## Exhibit 2.3

Marsh Creek Matrix of Required Retrofits to Covered Unit Interiors

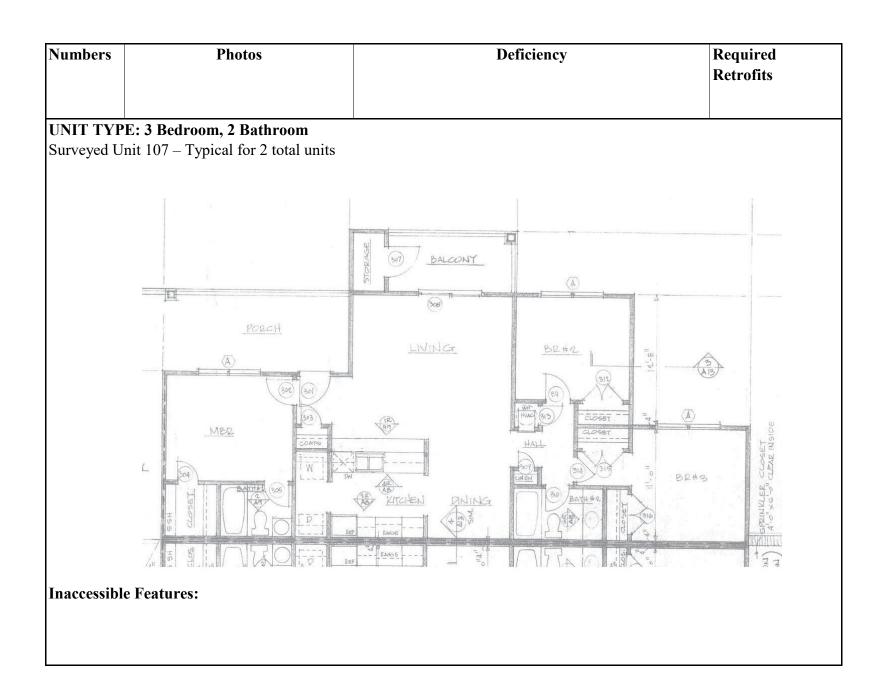
Numbers	Photos	Deficiency	Required Retrofits
25		Primary unit entry door thresholds are greater than 1/4 inch high and are not beveled at the interior side (maximum 1/4-inch change in level without bevel allowed).	Modify door thresholds to comply with Requirement 4(4).
		Location Height Location (inches) Photo	
		Unit 102, front door 3/4 5992.jpg	
		A maximum 1/4-inch vertical change in level is allowed without a bevel. (Guidelines Requirement 4(2); ANSI 1986 4.5.2).	
		Main entry threshold at Unit 102. (5992.jpg).

Numbers	Photos	D	eficiency	Required Retrofits
26		high and have changes i that are not beveled (ma	ies are more than 3/4 inches n level greater than 1/4 inch eximum 3/4-inch height inch change in level without	Modify door thresholds by installing a bevel on the interior side at a ratio of 1:2 to comply with
		Location	Height (inches) Photo	Requirement 4(4).
		Unit 102, patio	2-1/2 6040.jpg	
			gh threshold with bevel is Guidelines, Requirement 4	
			reshold height with bevel is s that are not the primary entry irement 4 (4)).	7
		Patio door threshold in (6039.jpg).	terior side at Unit 102.
